UNITED STATES PATENT AND TRADEMARK OFFICE

| APPLICATION NO. | FILING DATE | FIRST NAMED INVENTOR | ATTORNEY DOCKET NO. | CONFIRMATION NO. |
|--|-------------|----------------------|-----------------------------------|------------------------|
| 10/501,158 | 07/12/2004 | Philippe Thurot | 0510-1219 | 5346 |

Office Action Summary**Application No.**

DETAILED ACTION

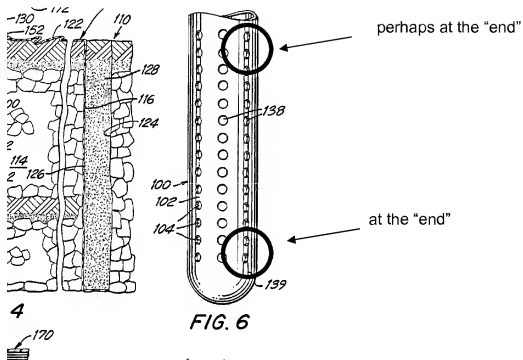
(a) The perforated tube of Katz is unsuitable for the sampling required of the present invention. The draw tube of Katz is engineered to outgas a large volume of

waste, and this is incompatible with the rapid measurement of oxygen content of several swaths.

Applicant has not provided any evidence suggesting that a draw tube engineered to outgas a large volume of waste would prove ineffective at monitoring the oxygen content of several swaths. Quite the opposite, draw tubes capable of removing large volumes of gas would provide a better indication of oxygen content within the processing waste by allowing for a larger sample size that is likely a better representation of the total gas within the waste. Indeed, Katz expressly teaches in column 2, lines 30-58 and in column 3, lines 12-40 that at least one remote bay (Figure 1:19) contains one or more gas measurement probes (Figure 2:10.1-10.5) that are capable of determining oxygen and carbon dioxide concentration.
